LES-13-00099-NRC

- Subject: Second Response to NRC Request for Additional Information on License Amendment Request (LAR) 12-10 Capacity Expansion of UUSA Facility (TAC L34193)
- Reference:
1. IN-13-00053-NRC, NRC Correspondence, dated April 25, First Request for Additional Information for License Amendment Request 12-10 Related to the Safety Analysis Report for Capacity Expansion of URENCO USA Facility (TAC L34193)
 2. LES-12-00162-NRC, License Amendment Request for Capacity Expansion of URENCO USA Facility (LAR-12-10), dated November 9, 2012
 3. LES-13-00068-NRC, Response to NRC Request for Additional Information on License Amendment Request (LAR) 12-10 Capacity Expansion of UUSA Facility (TAC L34193), dated May 28 2013.

Response to Request for Additional Information

Figure 2 Dose Map from 48Y Feed Cylinder Storage on Existing UBC Storage Pad and East Expanded UBC Storage Pad

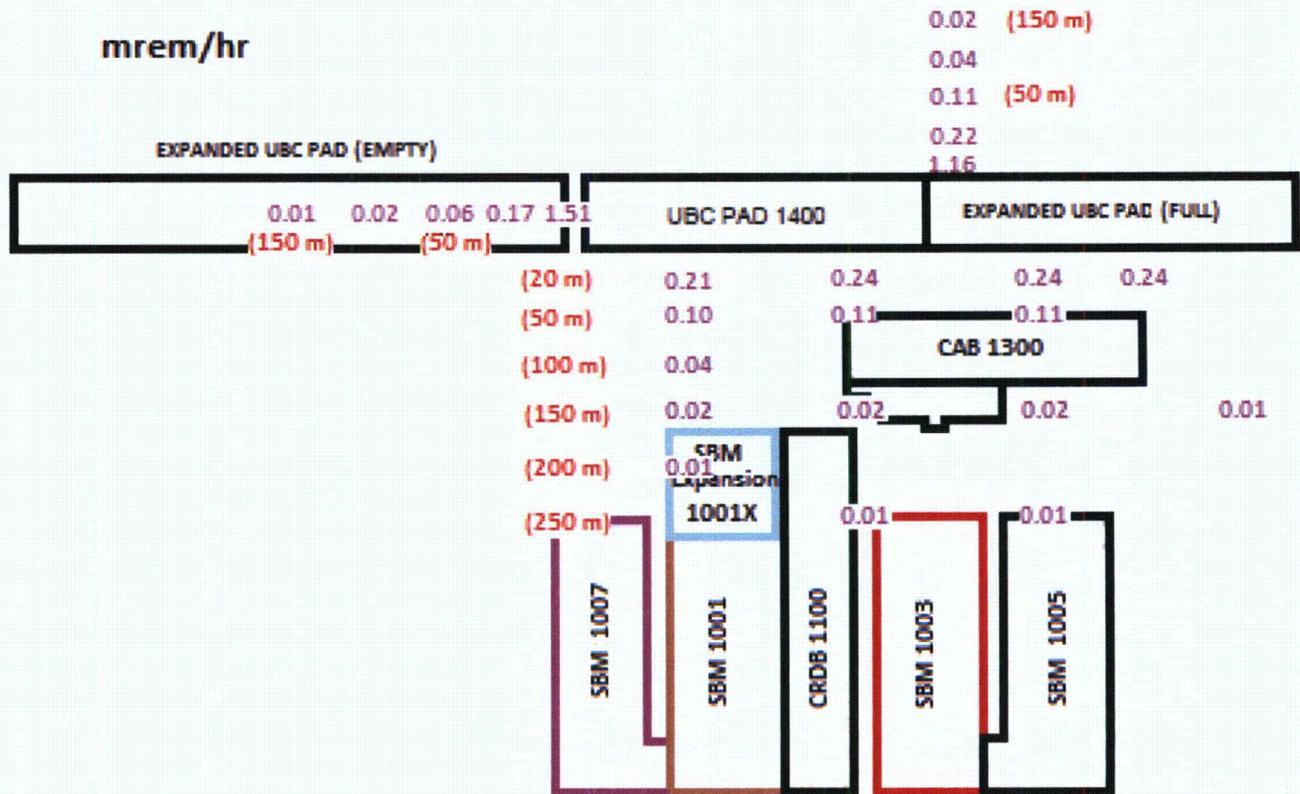
1. Table 4.1-2 lists a dose rate of < 0.01 mrem/hr for the plant general area excluding the separations building modules. Provide estimated dose rates in occupied areas close to the expanded uranium byproduct storage pad and describe the considerations given to these dose rates in the assessment of expanded facility operations.

Figure 1 below illustrates a dose map, in units of mrem/hr, of the existing UBC Storage Pad full with triple stacked filled 48Y feed cylinders. The estimated dose impact to the construction work force during the expansion/addition of the east segment of the UBC storage pad show that the maximum individual dose to a construction worker is estimated to be about 292mrem. Furthermore, if a worker, conservatively estimated, occupied an area 20 m from the surface of a cylinder stored on the UBC Storage Pad for 2000 hrs, he/she will receive a yearly dose of approximate 405 mrem. Both of these dose estimate values are below the annual occupational dose limit of 5 rams per 10CFR20.1201.
